AGENDA
MANOR PLANNING AND ZONING COMMISSION
105 E. EGGLESTON ST.
MANOR, TEXAS 78653
APRIL 8, 2015, 6:30 P.M.

Re: First Concept Plan Review for Manor
Commons SW
City of Manor, Texas

Re: First Concept Plan Review for
Manor Commons SW
City of Manor, Texas

RE: First Final Plat Review for Shadowglen Phase 2, Section 19B
City of Manor, Texas

CONCEPT PLAN MANOR COMMONS SW

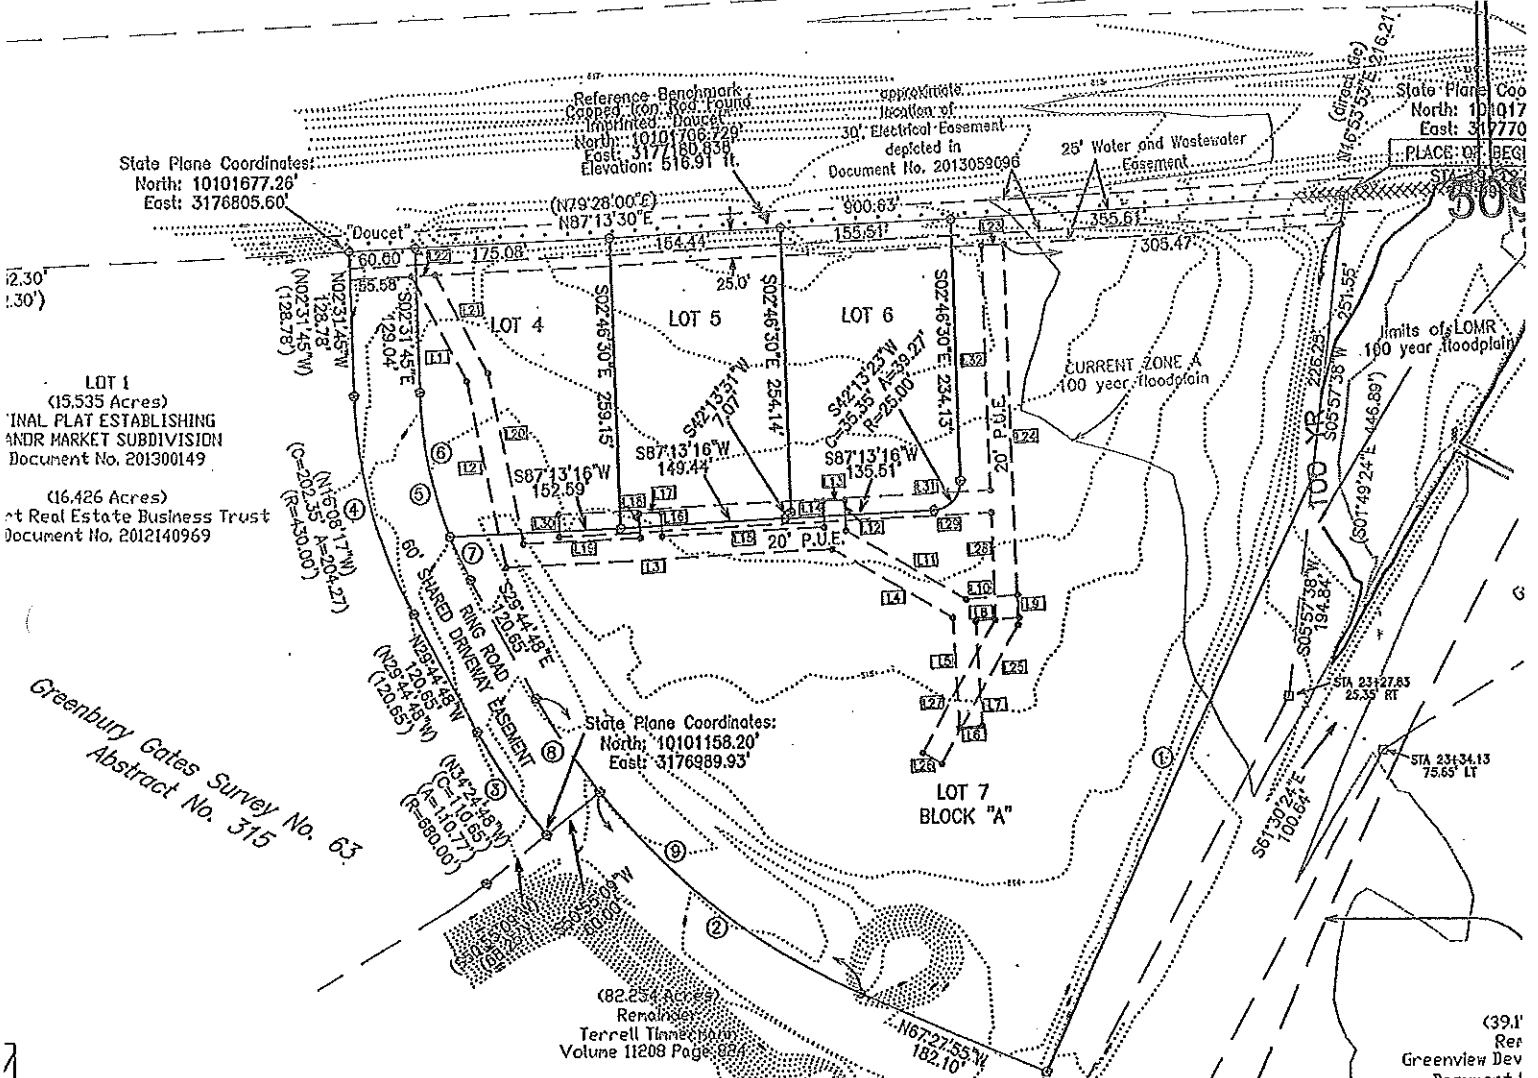
1. The location map on the concept plan is not to scale as required in Section 21(c)(3) of Subdivision Ordinance 263B. A location map drawn at a scale of two thousand (2,000) feet per inch showing the area within a one (1) mile radius of the proposed subdivision must be shown on the plan. Use of the latest USGS 7.5 minute quadrangle map is recommended.

2. The ring road is not shown in its entirety as required in Section 21(c)(9) of Subdivision Ordinance 263B. Proposed and existing arterial and collector streets to serve the general area must be shown on the plan.

3. The existing regulatory floodplain is not shown on the concept plan as required in Section 21(c)(11) of Subdivision Ordinance 263B. Significant drainage features and structures including any regulatory one hundred (100) year flood plains must be shown on the plan.

4. Approximate anticipated timing of proposed phases of development are not shown on the concept plan as required in Sections 21(c)(13) and 21(c)(16) of Subdivision Ordinance 263B. Anticipated timing of proposed phases of development must be included on the plan.

5. The plat incorrectly lists the property zoning district as C-3. Correct the zoning district designation to C-2.

RESPONSE: The locations may have been corrected to a scale of 1"=2000'.

RESPONSE: The limits of the private driveway have been shown from Hwy 290 to FM 973.

RESPONSE: The Zone A flood plain is shown and labeled and the proposed LOMR 100 yr flood plain has been labeled.

RESPONSE: See note 10 page 2. The entire plat will be recorded in a single phase.

RESPONSE: The zoning has been re-labeled to C-2.

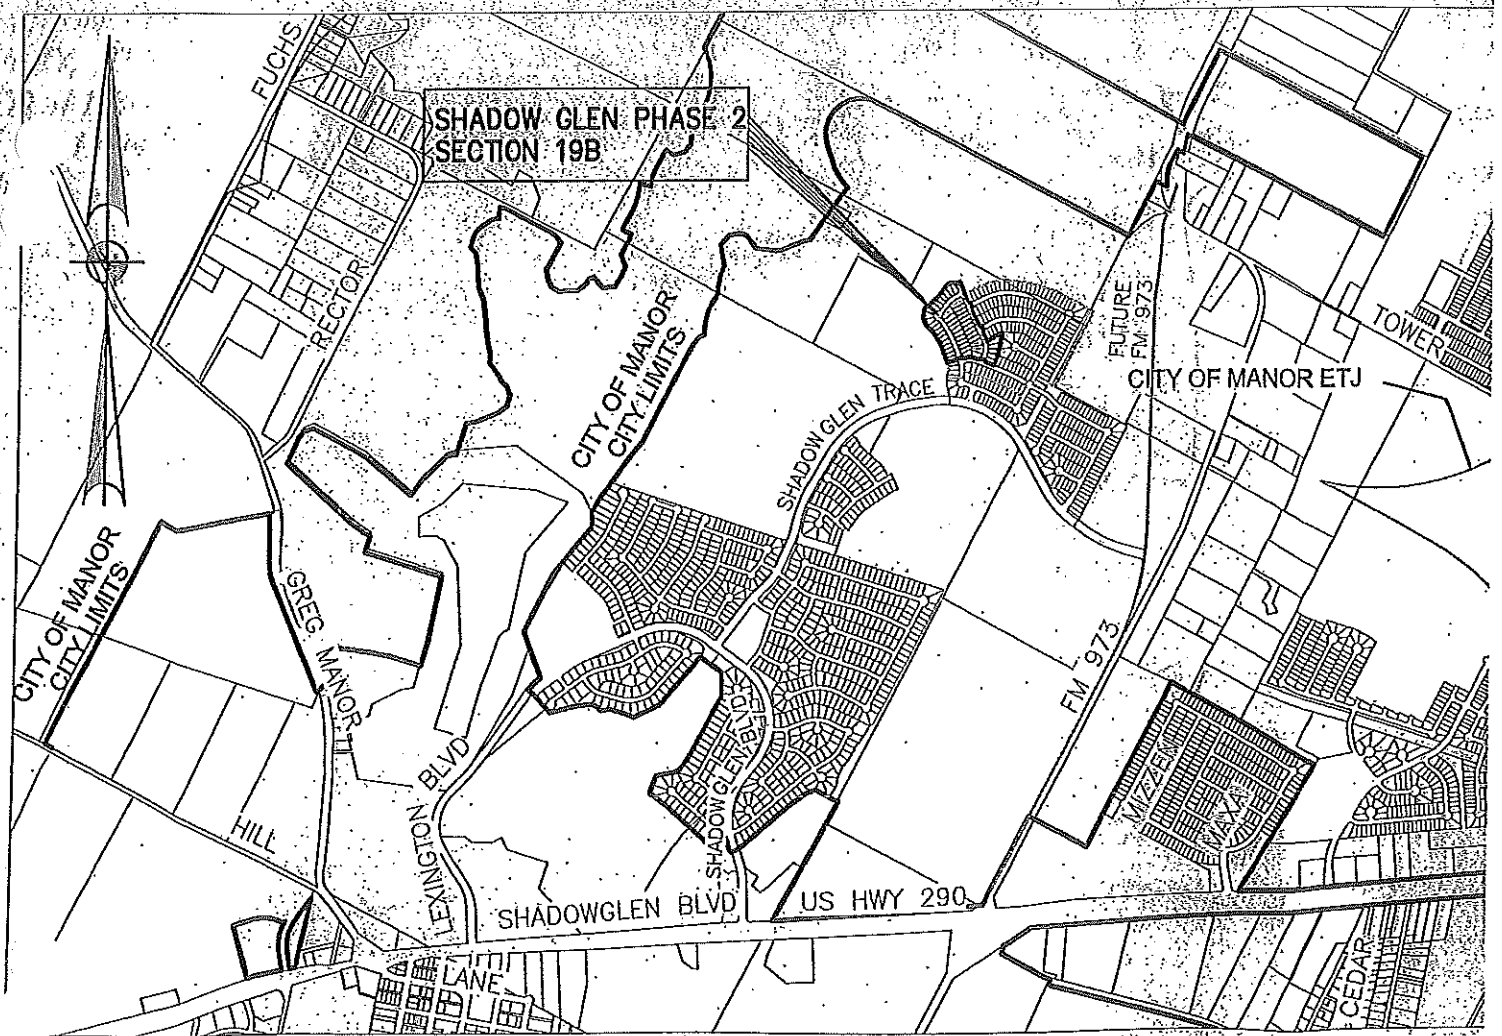
1. The address of the RPLS is not included on the plat as required in Section 24(c)(1)(ii) of Subdivision Ordinance 263. The date, scale, north point, addresses of the owner of record, developer, registered public surveyor, and registered professional engineer platting the tract must be shown on the plat.

2. Certification by registered professional engineer that water satisfactory for human consumption is available in adequate supply was not included on the plat as required in Section 24(c)(1)(vii) of Subdivision Ordinance 263. Certification from a registered professional engineer and approval by the State Health Department (if applicable) that water satisfactory for human consumption is available in adequate supply at the time of submission must be shown on the plat.

3. Provide a table summarizing that lot areas, widths and depths confirm to the requirements as established for the designated land use under the Minimum Development Standards for the project as required by Section 24(c)(1)(ix) of Subdivision Ordinance 263. The table must include analysis of the current section and the project overall.

4. Certification of new street names is not provided as required by Section 24(c)(1)(xi) of Subdivision Ordinance 263. Where new streets are being created and named, the applicant must have documentation from Travis County 911 Addressing demonstrating that the street names proposed on the Final Plat are not duplicated within the County.

5. Curve data for proposed streets does not meet minimum design criteria as required under the City Subdivision Ordinance. See construction plan review for comments on street geometric design.

Response: The address of the surveyor has been added to the cover of the plat.

Response: Per Section 24(c)(1)(ii) of the Subdivision Ordinance 263, the plat shall contain or have attached thereto the referenced certification. The certification was attached to the plat submittal in the form of a water and wastewater serviceability letter from the Wilbarger Creek Municipal Utility District No. 1. The water and wastewater serviceability letter has been included with this submittal for your reference.

Response: Per Exhibit C: Master Land Plan: Minimum Development Standards of the Development Agreement for the Shadowglen Subdivision between the City of Manor and Owner, the minimum standards for single family residential developments are as follows:

Response: Correspondance from Michael Murphy at Travis County's 911 Addressing Department is attached showing the acceptance of Sherry Berry Way. Fallspring Way has been accepted in the Preliminary Plan as the continuation of a previously approved road.

Response: These radii have been approved in the preliminary plan and have been used throughout the Shadowglen development. In all future preliminary plans, the 300 ft radii will be used. See attached Preliminary Plan for reference.
